# ARIZONA DEPARTMENT OF ENVIRONMENTAL QUALITY

**Re: Review of (revised) Non-Time-Critical Removal Action Work Plan**  
Closed Loop 59<sup>th</sup> Avenue Warehouse  
435 South 59<sup>th</sup> Avenue, Suite 120 and 130  
Phoenix, Arizona 85043  
VRP Site Code: 513246-00

**Re: Review of Non-Time-Critical Removal Action Work Plan**  
Closed Loop 59<sup>th</sup> Avenue Warehouse  
435 South 59<sup>th</sup> Avenue, Suite 120 and 130  
Phoenix, Arizona 85043  
VRP Site Code: 513246-00

**Response To ADEQ Comments dated February 24, 2020**  
**Non-Time Critical Removal Action Work Plan**  
**Closed Loop 59<sup>th</sup> Avenue Warehouse**  
**435 South 59<sup>th</sup> Avenue, Suite 120 and 130**  
**Phoenix, Arizona 85043**  
**VRP Site Code 513246-00**

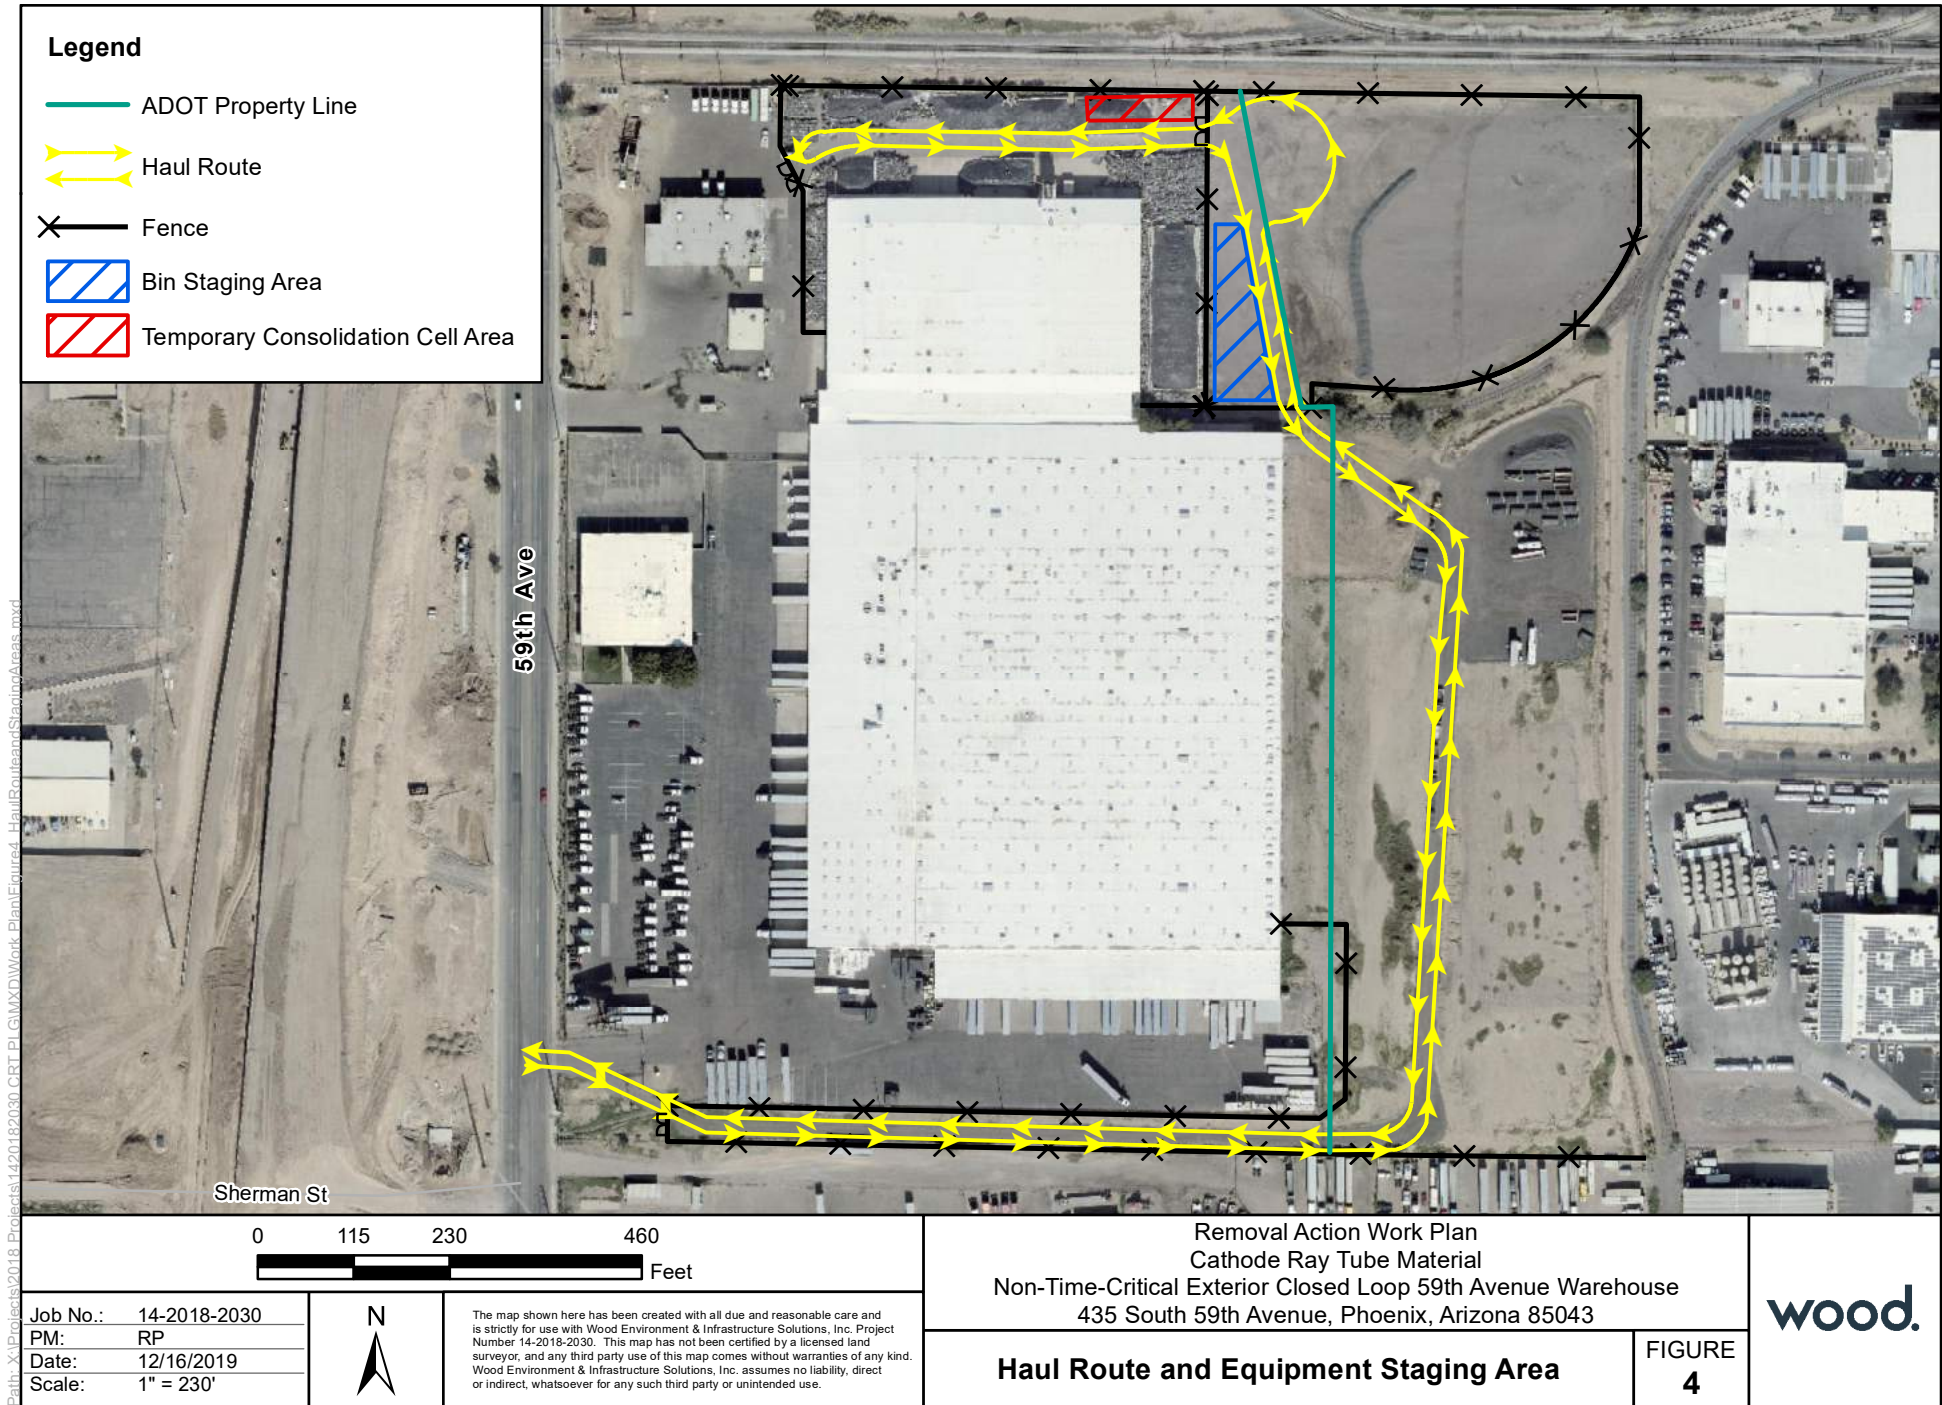
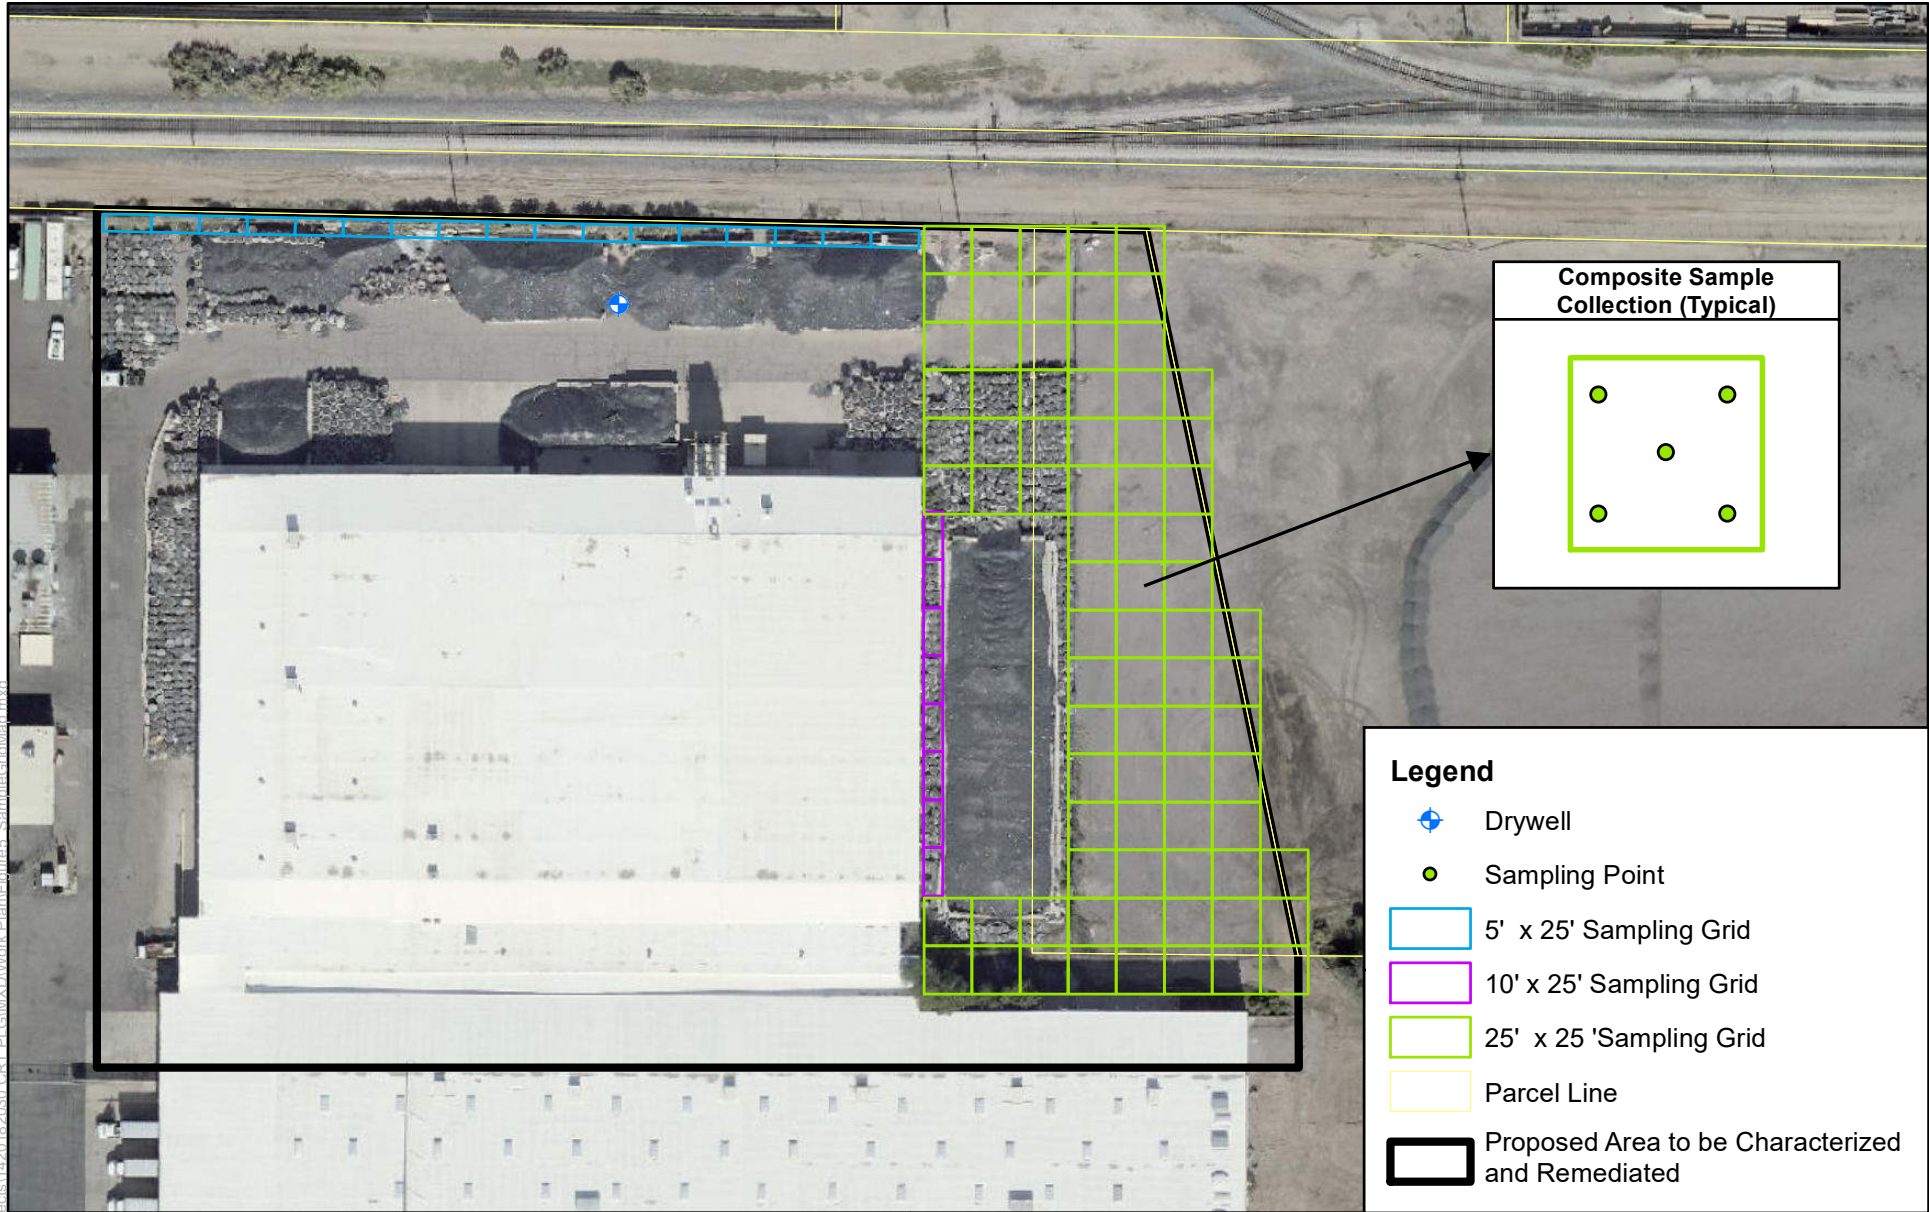
23. Please add drywell location(s) on Figure 5.

23		Figure 5	Please add drywell location(s) on Figure 5.	Figure 5 has been revised to include the location of the drywell.
